CITY OF TAMPA

ADDENDUM 6

September 28, 2018

Contract 15-C-00044; Louisiana Pump Station Rehabilitation

SHEET
C-7

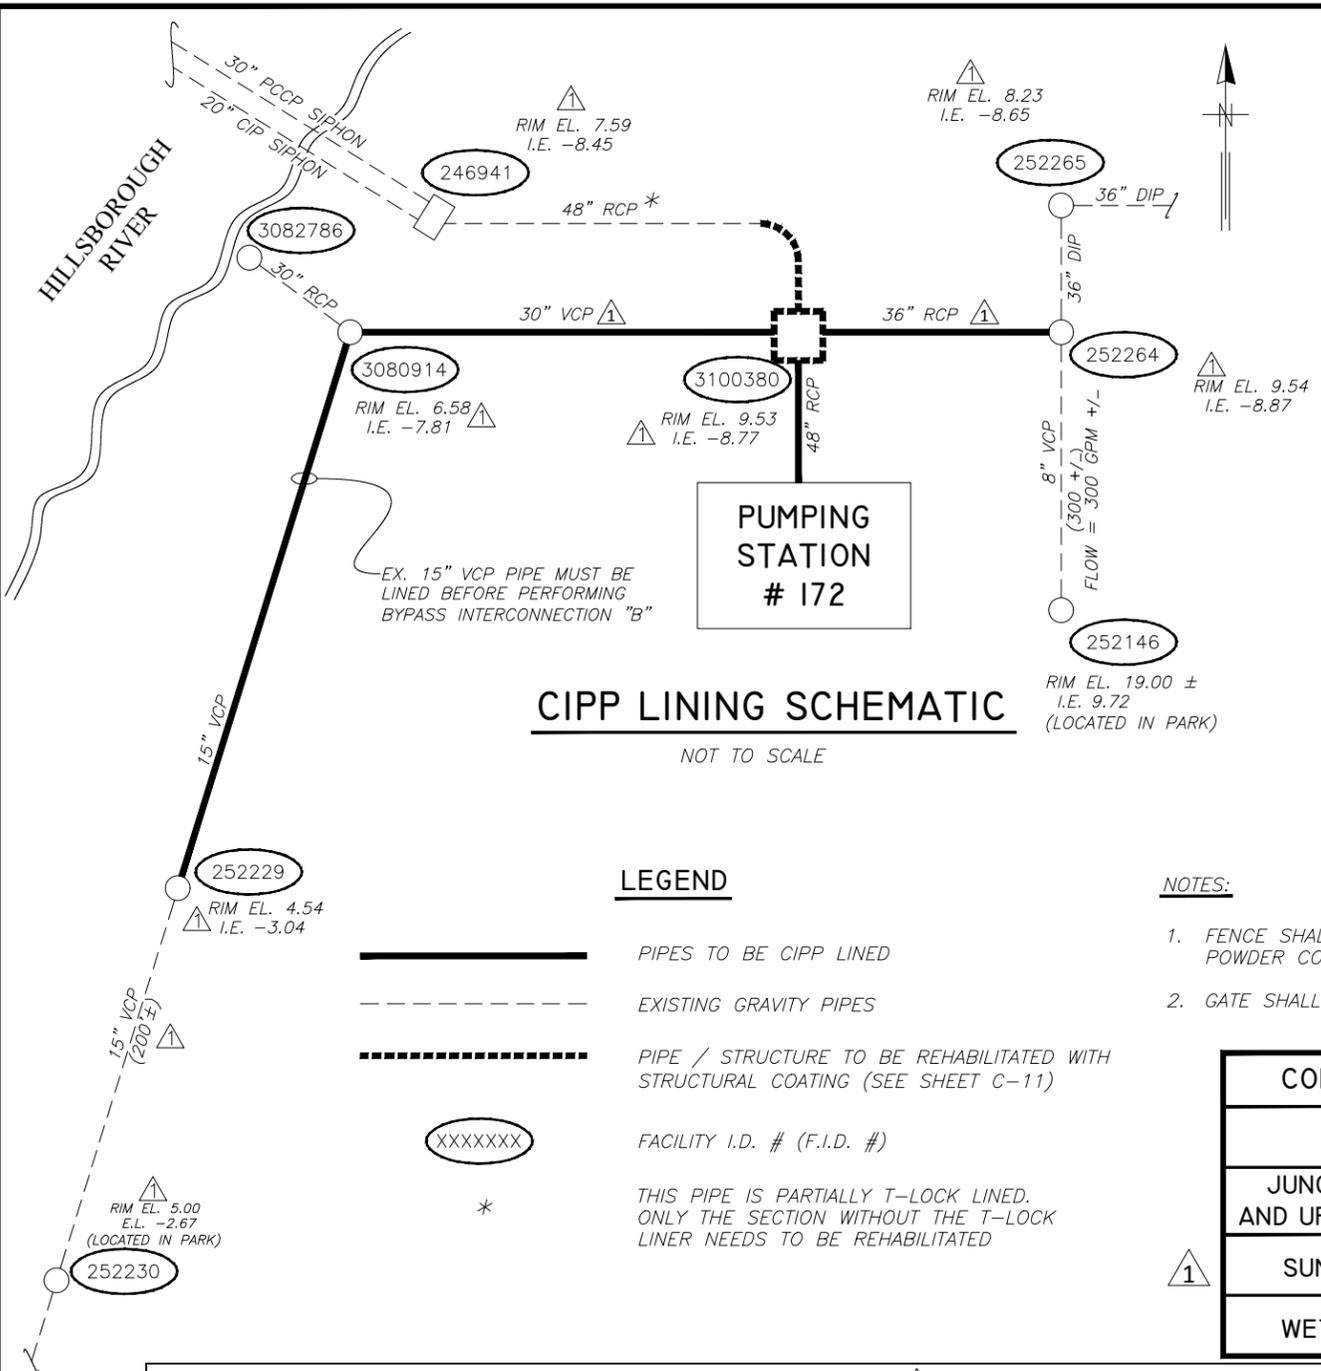
No.	DATE	REVISIONS
3		
	9/14/18	EX. PIPE MATERIAL / LEGEND
	9/10/18	HIGHLIGHTED PROP. CURB / FENCE NOTES / DELETED MISC. NOTES

SHEET
C-16

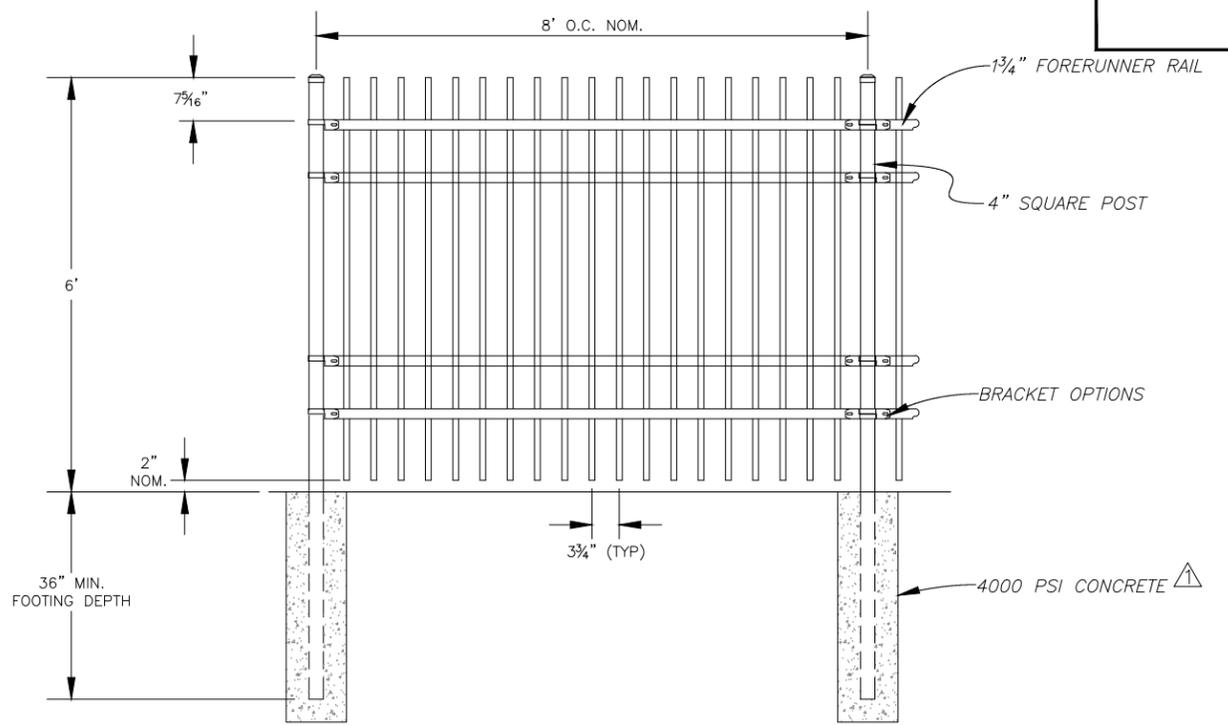
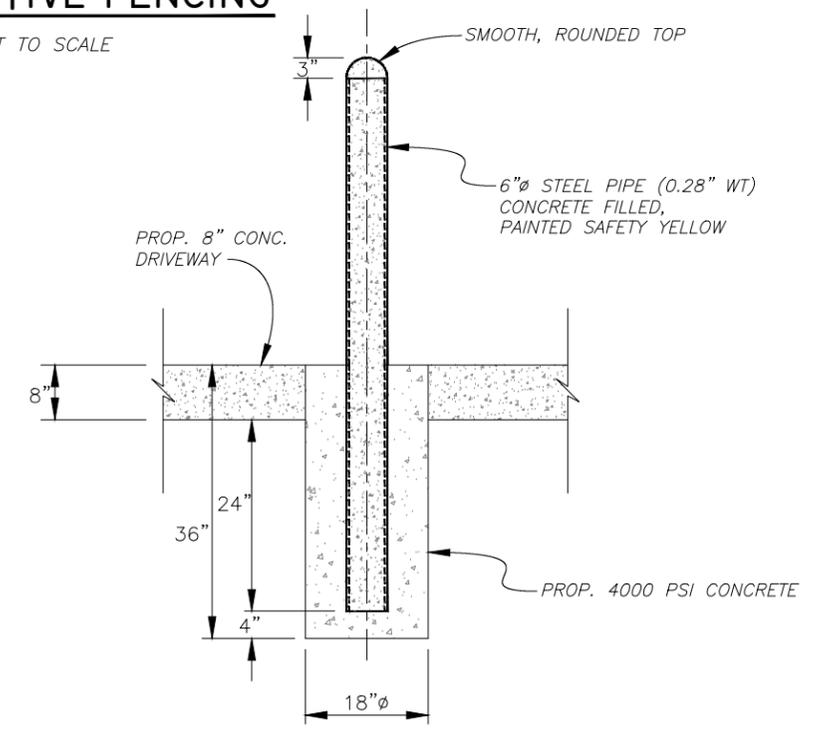
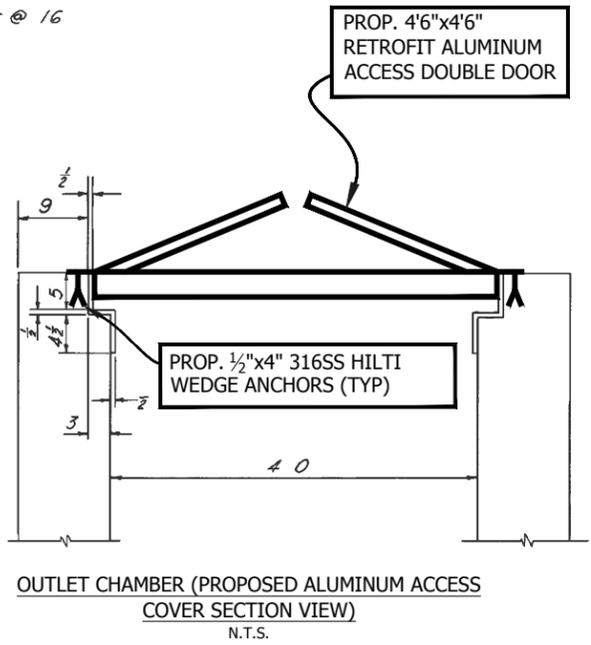
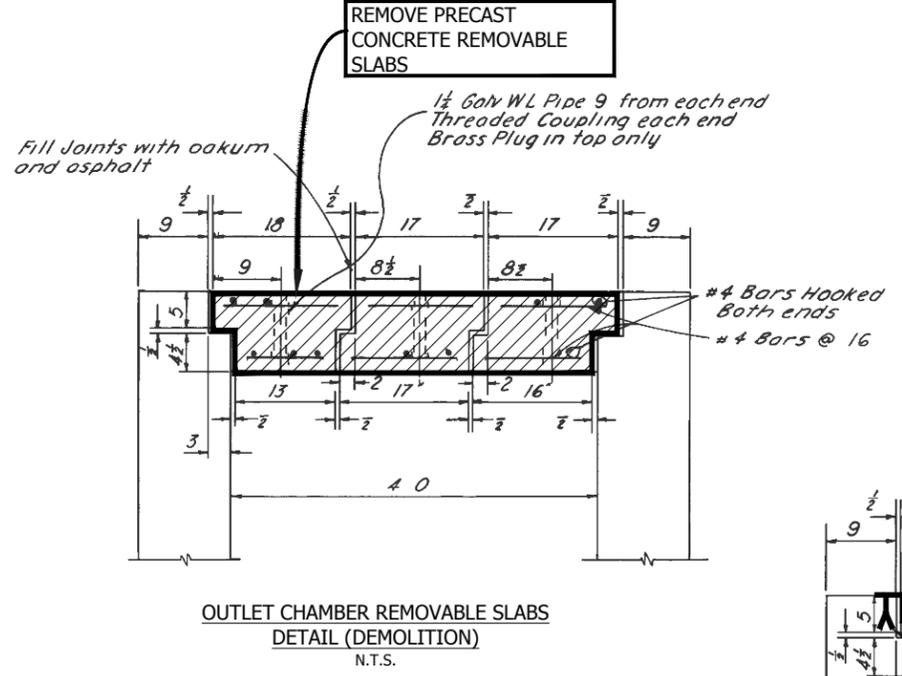
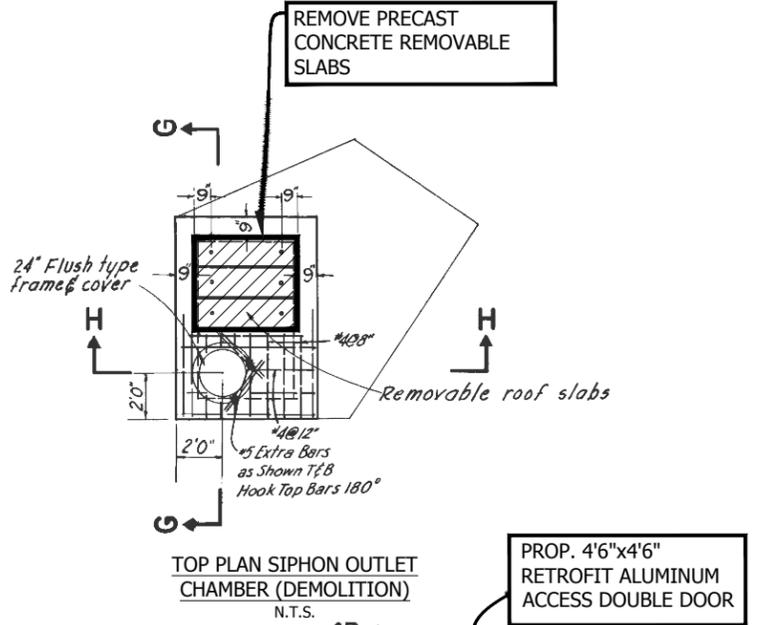
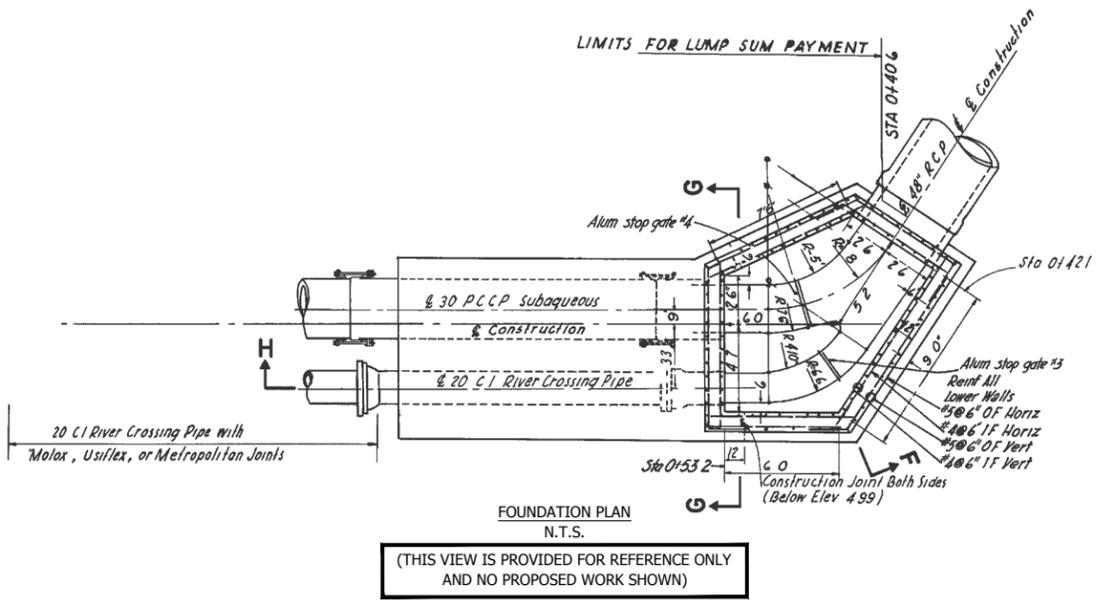
No.	DATE	REVISIONS
3		
2		
1	9/10/18	ADDED RIM / INVERTS / FENCE POST CONCRETE / EX. PIPE MAT'L / FLOW RATES

SHEET
M-13

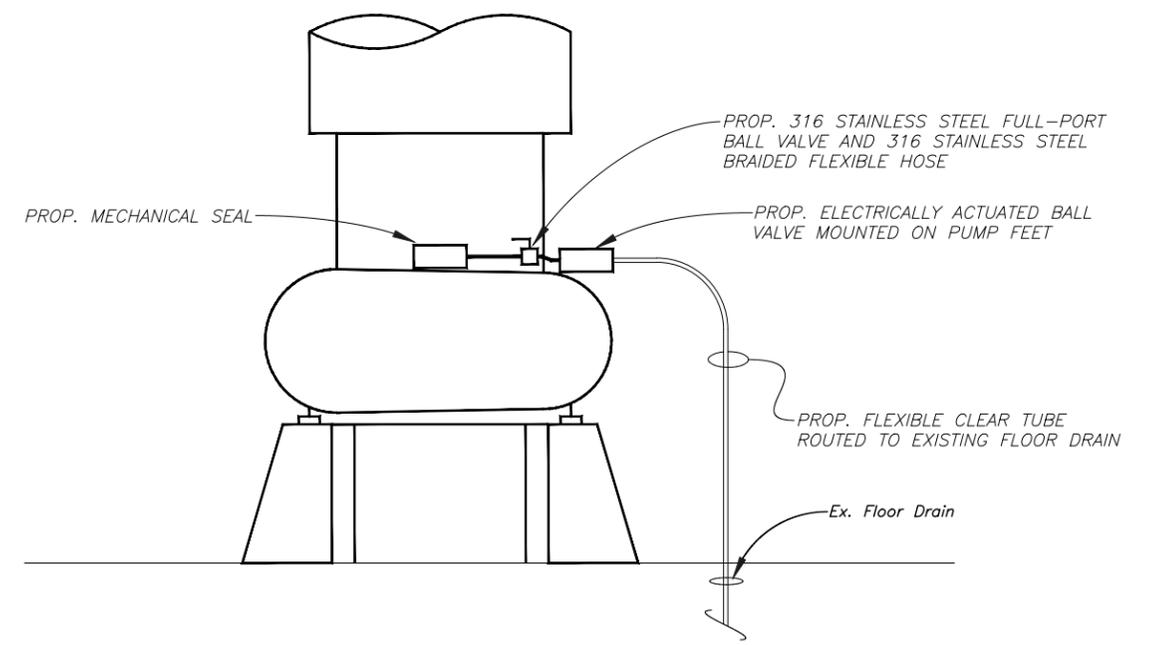
No.	DATE	REVISIONS
3		
2		
①	9/10/18	ADDENDUM - SUMP PUMP

NOTE:
SUMP PUMP SHALL BE A LIBERTY LE51A MODEL 1/2 H.P. OR APPROVED EQUAL.
INSTALL PER MANUFACTURER RECOMMENDATIONS.
